CITY OF GERMANTOWN
ADDENDUM NO.1
COG2021-01 Packaged Unit Replacement

Project
**PACKAGED UNIT
REPLACEMENT
GERMANTOWN
ECONOMIC
DEVELOPMENT
BUILDING**

M101

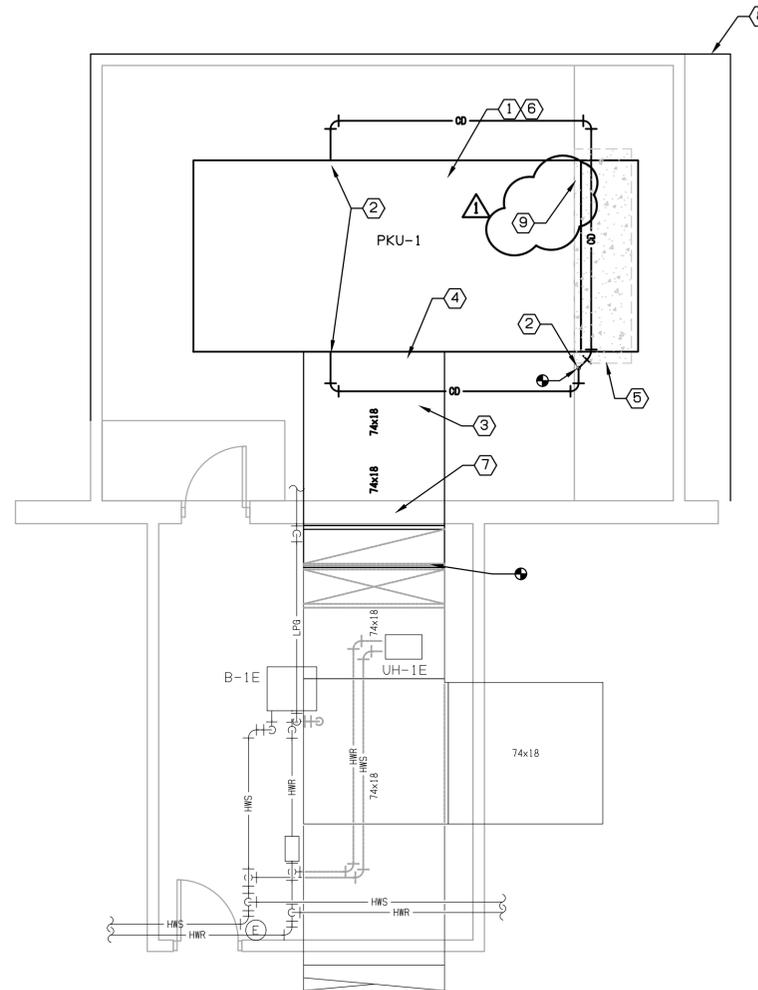
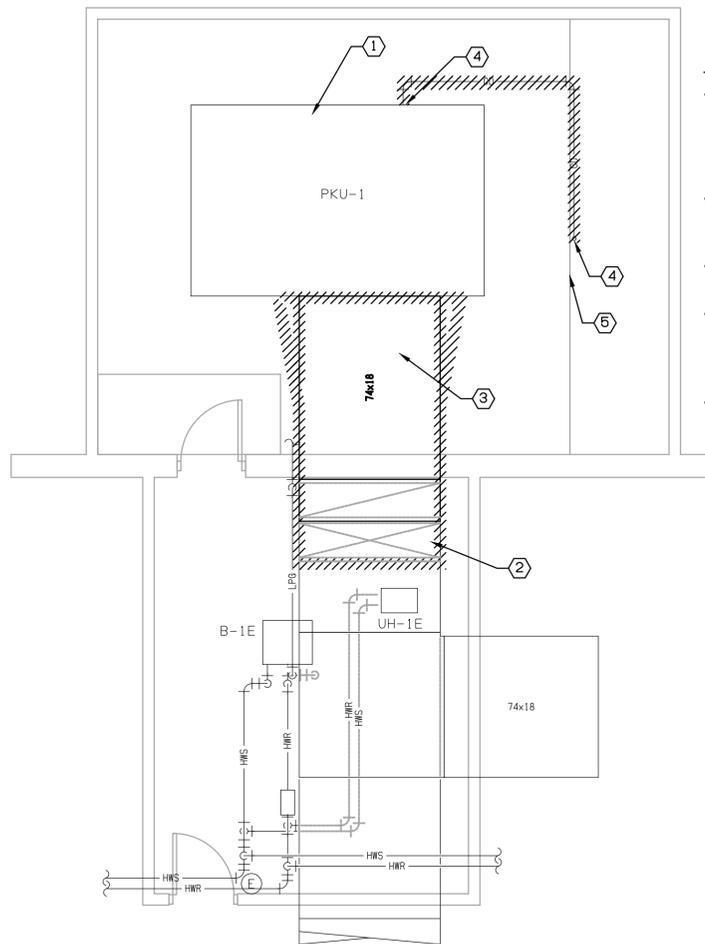
1. Remove and replace sheet M101 dated September 2, 2020 with attached sheet M101 with revision date 09-24-2020.
2. Remove and replace sheet M201 dated September 2, 2020 with attached sheet M201 with revision date 09-24-2020
